DATE: May 31, 2024

TO: Planning Commission

FROM: Comprehensive and Neighborhood Planning Committee

SUBJECT: River Balcony Master Plan Proposed Addendum – Basis of Design Report

RIVER BALCONY SCHEMATIC PLAN

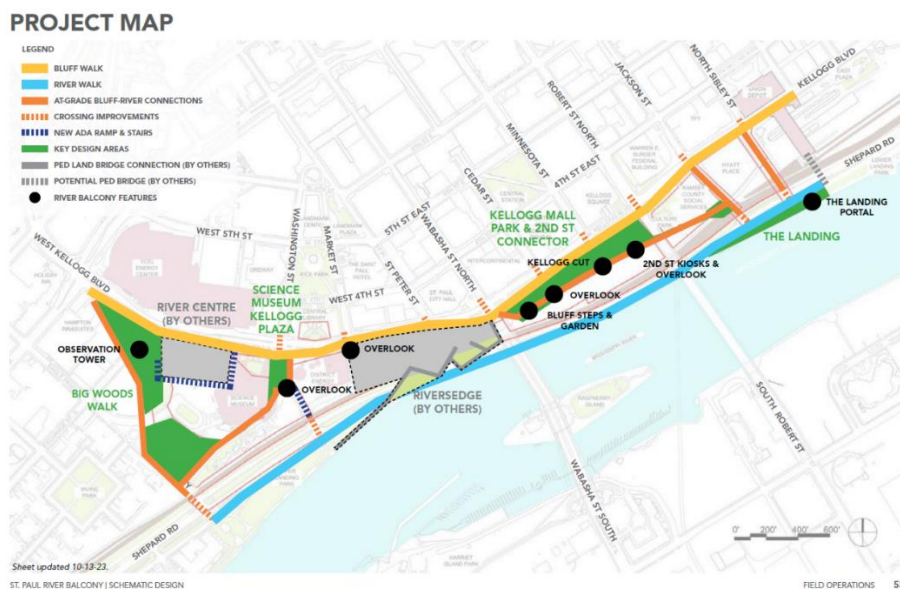
The basis of design report includes key additions that were not included in the master plan. These additions are summarized here and assessed in detail below.

- Adding the “Kellogg Cut” that provides access from Kellogg Mall Park to 2nd Street
- Converting 2nd Street from a vehicular to pedestrian corridor
- Explore traffic calming, lane reductions, and other measures across Shepard Road
- Proposing improvements to Lambert’s Landing at the east end of the River Balcony
- Eight overlooks at various points along the River Balcony

The basis of design report uses Kellogg Mall Park, one of the largest city-owned parcels along the project area and enhances the central core of the River Balcony by adding the “Kellogg Cut” to open views and provide access to 2nd street which is converted to a pedestrian corridor.

OVERALL SITE PLAN

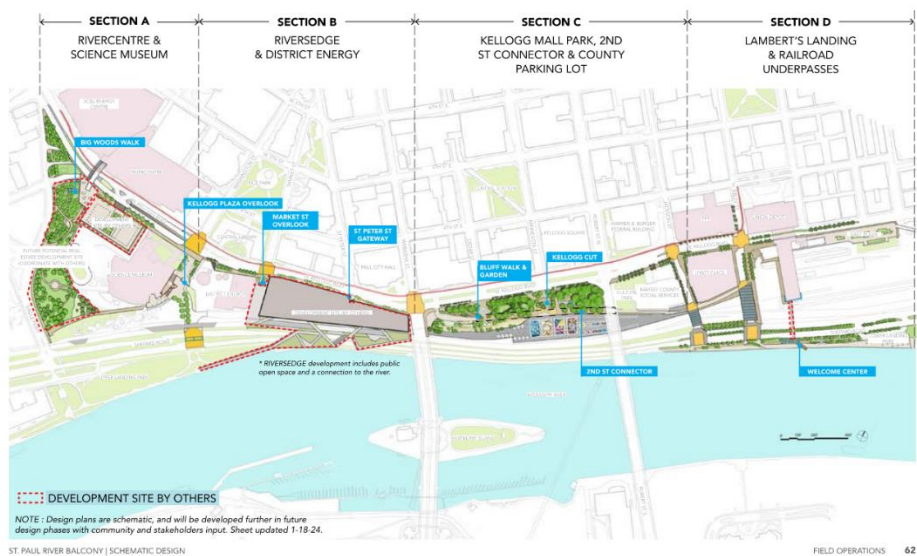
Discussion of the master plan falls into three districts – East, Central, and West. The elements of each of the districts are discussed below in items 1-22 and identify what the master plan calls for and what the basis of design report shows. Note, the basis of design report discusses the elements of the master plan according to four sections, not three districts: Section A – RiverCentre & Science Museum; Section B – RiversEdge & District Energy; Section C – Kellogg Mall Park, 2nd Street Connector & County Parking Lot (Interim improvements); and Section D - Lambert’s Landing & Railroad Underpasses. The Four Sections of the basis of design report are shown below.

KELLOGG CUT AT MINNESOTA ST

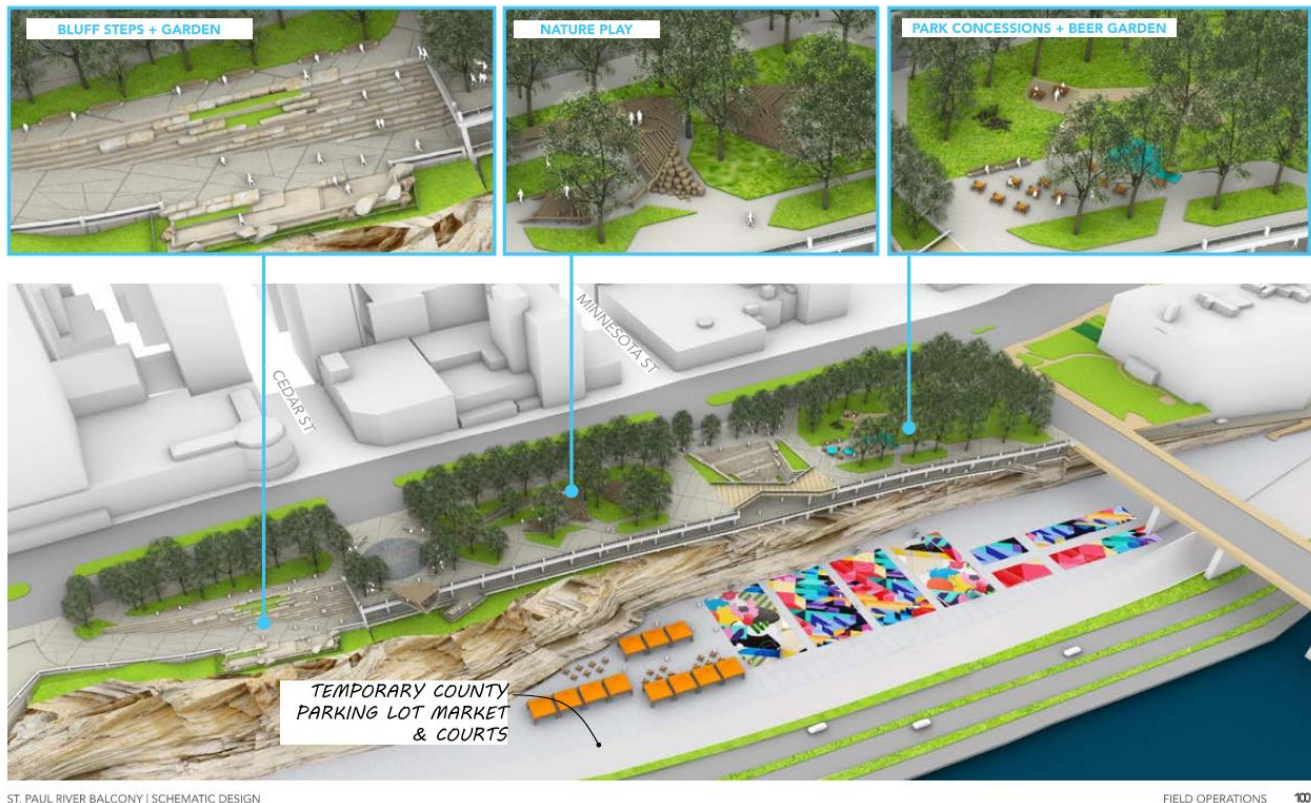
9. Balcony along south edge of Kellogg Mall Park: Kellogg Mall Park will become the central focus for city-wide events and neighborhood activities along the River Balcony. To recapture the Mississippi River as an important aspect of the overall experience of Kellogg Mall Park, the River Balcony railing will be transparent with extended platforms to allow walkers to move beyond the existing bluff and look back to the last remaining segment of natural face of the bluff.

Basis of Design Report: Kellogg Mall Park remains a central focus of the River Balcony including a feature referred to as the Kellogg Cut at the terminus of Minnesota Street. The Kellogg Cut cuts into the park to create an access down to 2nd Street. The design also includes an extended overlook at the terminus of Cedar Street to look back at the natural bluff face.
